CANYON CREEK RANCH

LOCATED IN THE SW 1/4 OF SECTION 14
TOWNSHIP 12 SOUTH, RANGE 66 WEST OF THE 6TH P.M.
STREET IMPROVEMENT PLANS
COUNTY OF EL PASO, STATE OF COLORADO

PCD FILE NO. SF-2434

CANYON CREEK RANCH
COVER SHEET

**ALIGNMENT 2 PROFILE (2)
STA 15+25.00 TO 22+65.41**

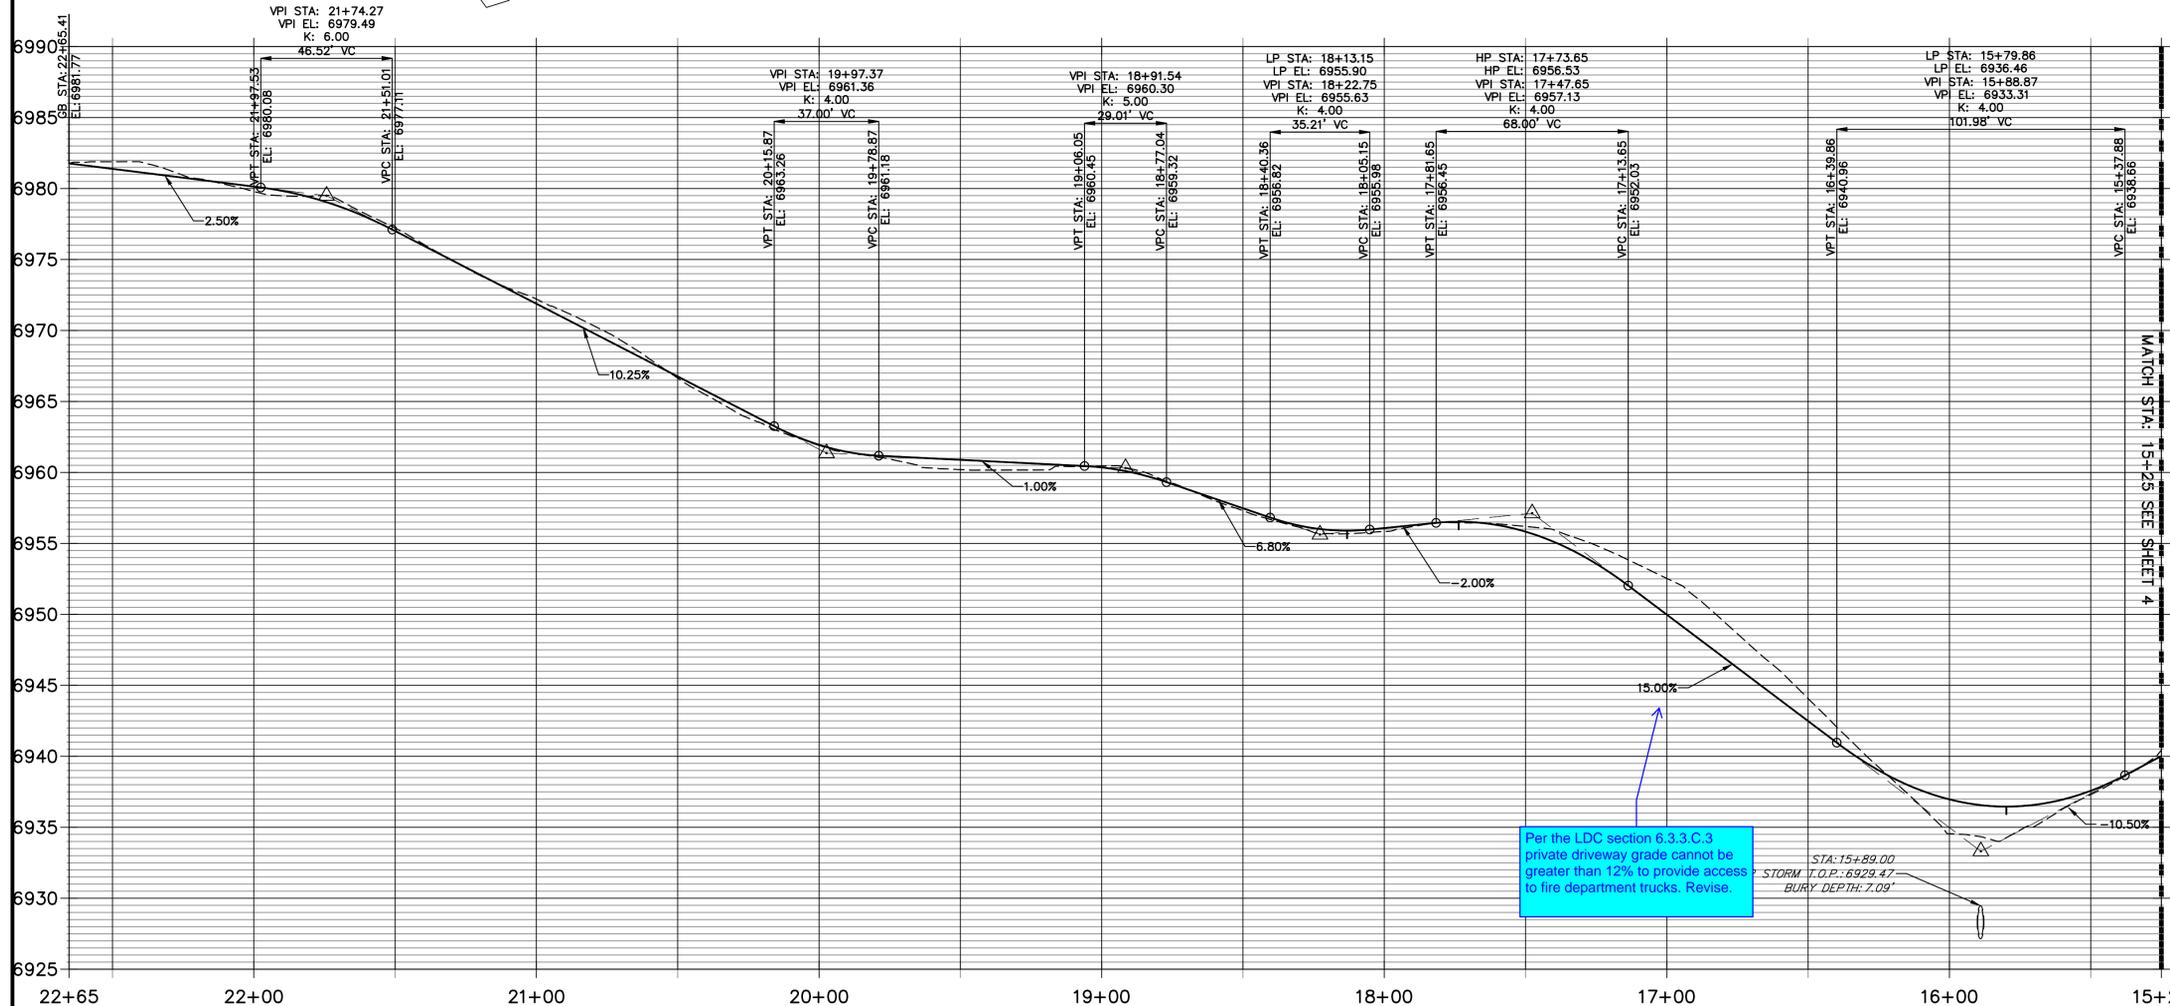
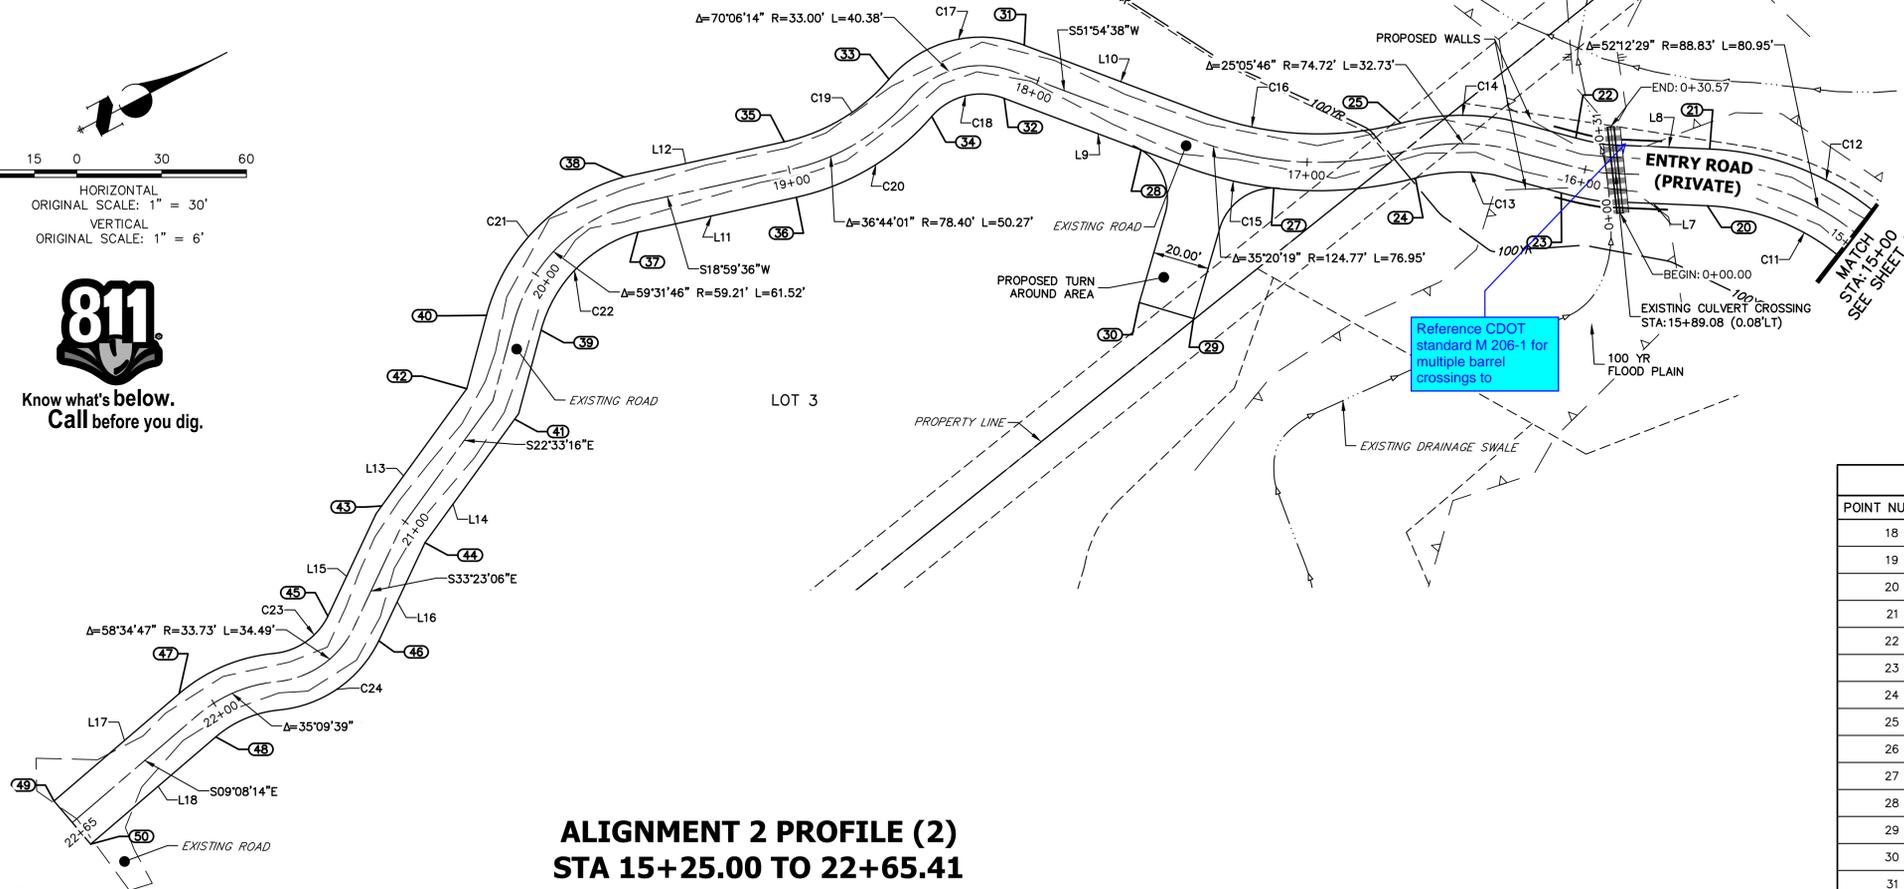
Per the LDC section 6.3.3.C.3 private driveway grade cannot be greater than 12% to provide access to fire department trucks. Revise.
